**NSLPP MEETING HELD ON 01/12/21****Attachments:**

ADDRESS/WARD: 80 Cairo Street, Cammeray (T)**APPLICATION No:** DA 209/21**PROPOSAL:** Substantial alterations and additions to an existing dual occupancy including a new car space in the existing garage, and a roof extension.**PLANS REF:**

OWNER: Brigit Salter**APPLICANT:** Belinda Walter, Atlas Urban**AUTHOR:** Andrew Beveridge, Assessment Officer**DATE OF REPORT:** 18 November 2021**DATE LODGED:** 8 July 2021**RECOMMENDATION:** Approval (Deferred commencement)

Figure 3. Western (rear) elevation

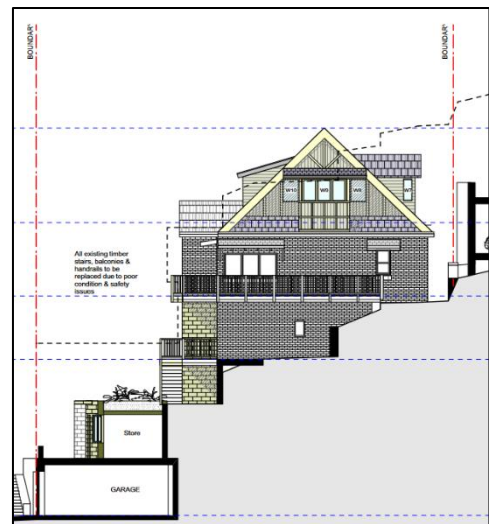
Figure 16: Western elevation plan of the proposal showing the level difference between the subject site and No. 74-78 Cairo Street to the south (left).

The affected views are across to Northbridge, which is considered to be a minor view that is accessed across side boundaries. Only a section of this view will be affected by the proposed works and other more significant views are enjoyed by the residents of this dwelling to the north-east (towards Long Bay) and north-west (towards the Long Gully Bridge), that will largely be unaffected by the proposal. Accordingly, it is considered unnecessary to require design changes to retain the minor view with no iconic features. Therefore, the proposal is considered to provide reasonable view sharing.

Figure 4. Northern side (Pine Street) elevation.

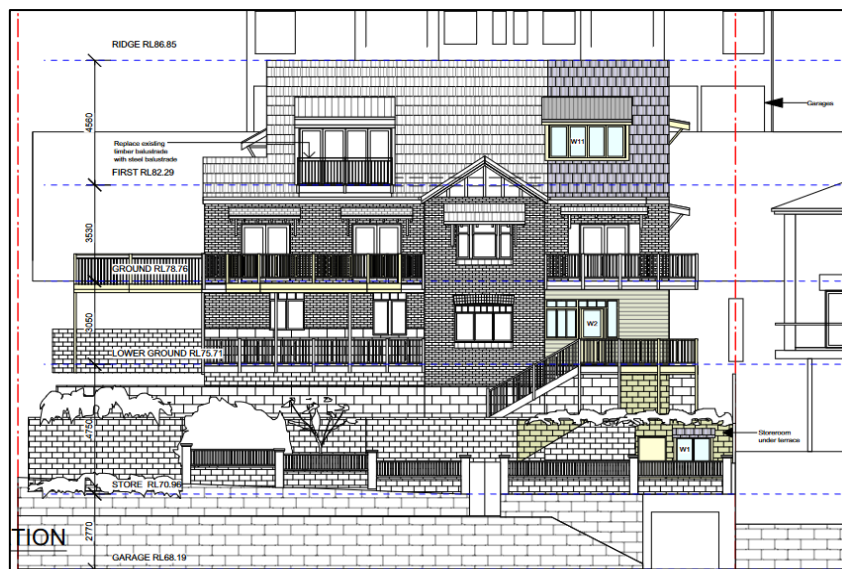
The proposed north-facing dormer window is not considered to be characteristic of the area or the Plateau Conservation Area, as it will result in a northern roof plane that is dominated by dormer windows given the presence of a wide balcony dormer on the north-eastern corner of the roof plane. The proposed new dormer will be a further uncharacteristic addition to the northern elevation of the site, which is highly visible from the public domain, particularly on Pine Street.

2. The north-facing first-floor dormer window, in combination with the existing over-scaled balcony dormer window to the east, will result in a northern roof plane that is dominated by dormer windows comprising more than 1/3 of its length.

Sheet Title
MATERIALS SCHEDULE

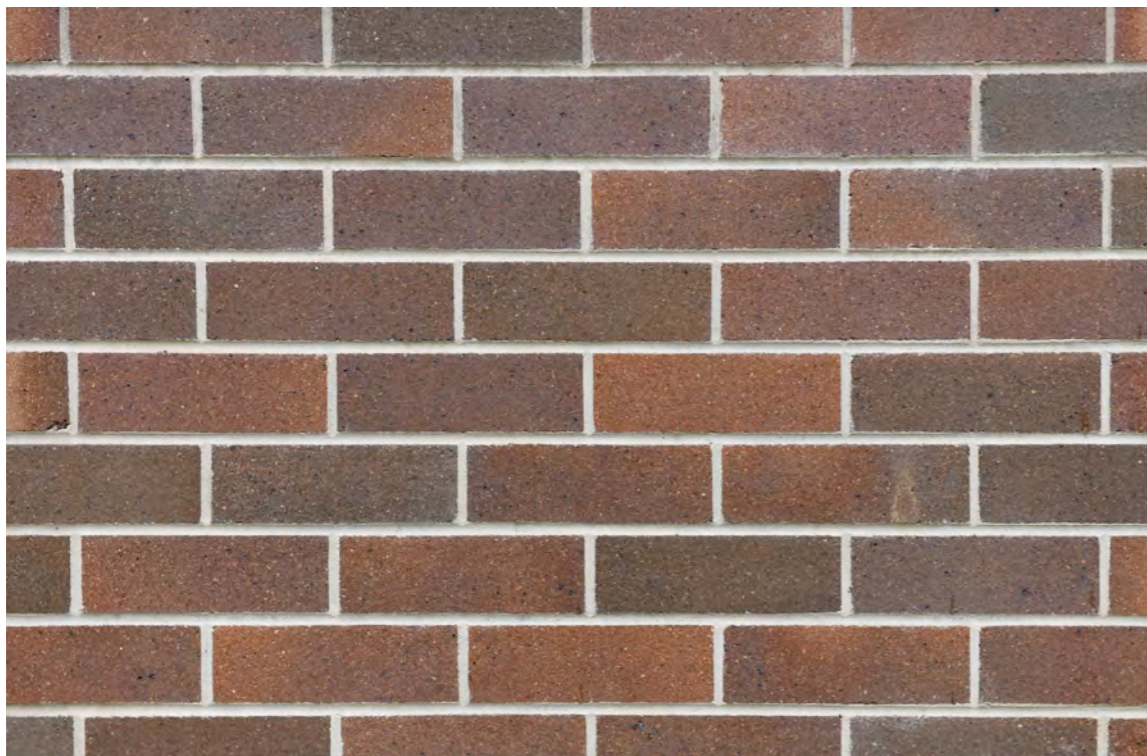
13.9.4 Materials – Objective O1 To ensure that materials and finishes are consistent with the characteristic elements of the heritage item or heritage conservation areas – The submitted Materials Schedule includes slate roof tiles which are inconsistent with the existing Marseilles terracotta tile roof and are not supported. The plans also indicate the replacement of a timber balustrade on the existing balcony dormer with a steel palisade. This is not supported as it will introduce an uncharacteristic contemporary material and will result in the wide glazed opening of the dormer being more visible from the public domain.

4. The proposed slate roof to replace the existing red tiled roof is also not characteristic.
5. The proposed exterior colour scheme comprising ‘Resene Nocturnal’, ‘Half Nocturnal’ and ‘Black White’ is a dark palette with little contrast, and is not sympathetic to the conservation area or for a property within a bushland buffer zone, which specify muted and neutral tones.

<p>1.4.12 Materials</p>	<p>No</p>	<p>The proposed schedule of materials and paint schedule provided with the application are not considered to be acceptable or sympathetic to the character of the existing 1911 dwelling or the Plateau Conservation Area. The proposed steel balustrade replacements add an uncharacteristic contemporary material to areas that are highly visible from the public domain.</p> <p>The proposed slate roof will replace the existing characteristic tiled roof of the existing dwelling and is not supported. The proposed colour scheme is also too dark, with little contrast and is not sympathetic to the colour scheme used on the existing dwelling or the conservation area. Consequently, the proposed materials and colours are recommended to be deleted by condition to be replaced with more sympathetic colours and materials (see Condition AA1).</p>
